ECE/TRANS/WP.29/2006/15  
19 December 2005

PROPOSAL FOR 03 SERIES OF AMENDMENTS TO REGULATION No. 48

(Installation of lighting and light-signalling devices)

Transmitted by the Working Party on Lighting and Light-Signalling (GRE)

Model A

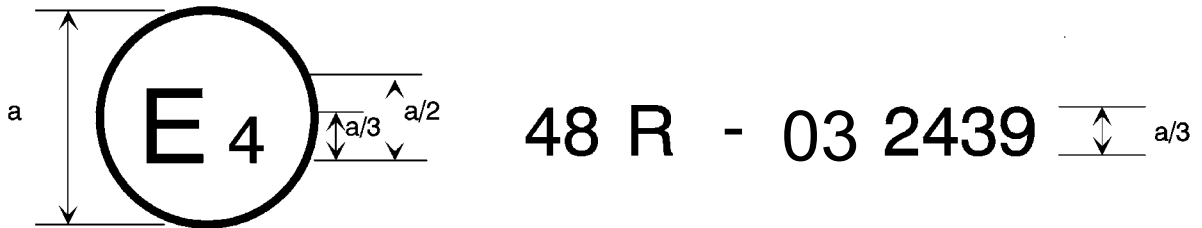
Annex 2, amend to read:

The above approval mark affixed to a vehicle shows that the vehicle type concerned has, with regard to the installation of lighting and light-signalling devices, been approved in the Netherlands (E4) pursuant to Regulation No. 48 as amended by the 03 series of amendments. The approval number indicates that the approval was granted in accordance with the requirements of Regulation No. 48 as amended by the 03 series of amendments.

Model B

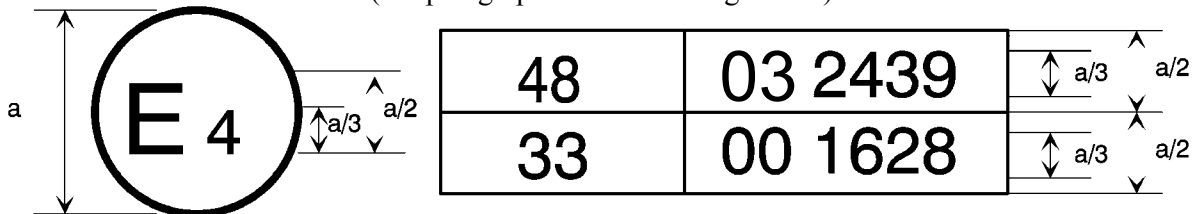
The above approval mark affixed to a vehicle shows that the vehicle type concerned has been approved in the Netherlands (E4) pursuant to Regulation No. 48 as amended by the 03 series of amendments and Regulation No. 33. 1/ The approval number indicates that, at the dates when the respective approvals were given, Regulation No. 48 was amended by the 03 series of amendments and Regulation No. 33 was still in its original form."

Figure 1

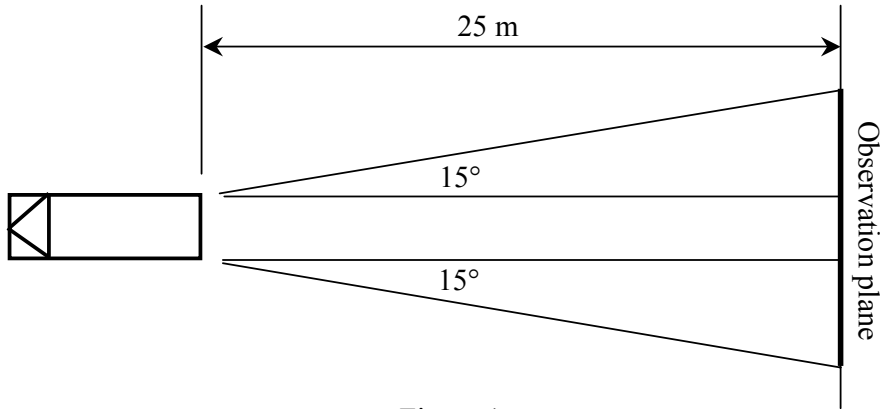
- 6.21.5.1. for rear conspicuity markings (see Annex 11, Figure 1) the observation plane is perpendicular to the longitudinal axis of the vehicle situated 25 m from the extreme end of the vehicle and bounded by:

- 6.21.5.1.1. in height, by two horizontal planes 1 m and 3.0 m respectively above the ground,
- 6.21.5.1.2. in width, by two vertical planes which form an angle of 15° outwards from the vehicle's median longitudinal plane and which pass through the intersection of the vertical planes parallel to the vehicle's median longitudinal plane delimiting the vehicle's overall width, and the plane perpendicular to the longitudinal axis of the vehicle that delimits the end of the vehicle.

Figure 2"

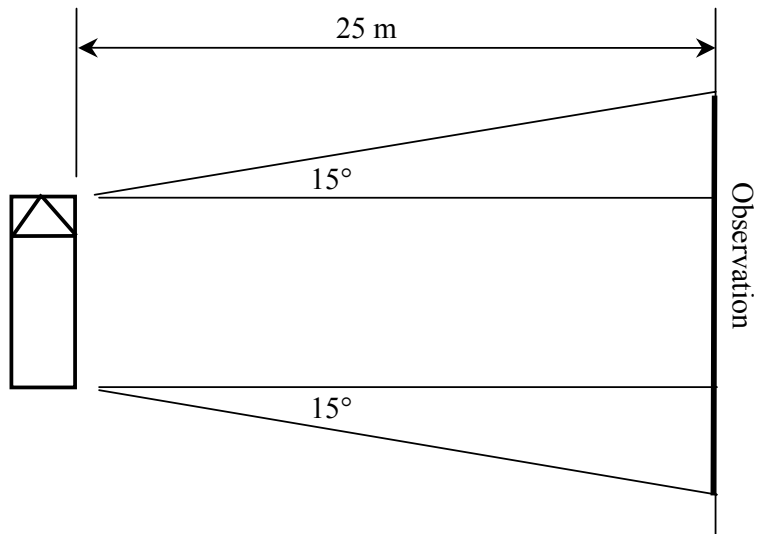
- 6.21.5.2. for side conspicuity markings (see Annex 11, figure 2) the observation plane is parallel to the longitudinal median plane of the vehicles situated 25 m from the extreme outer edge of the vehicle and bounded by:

- 6.21.5.2.1. in height, by two horizontal planes 1 m and 3.0 m respectively above the ground,
- 6.21.5.2.2. in width, by two vertical planes which form an angle of 15° outwards from a plane perpendicular to the vehicle's longitudinal axis and which pass through the intersection of the vertical planes perpendicular to the vehicle's longitudinal axis delimiting the vehicle's overall length and the extreme outer edge of the vehicle.
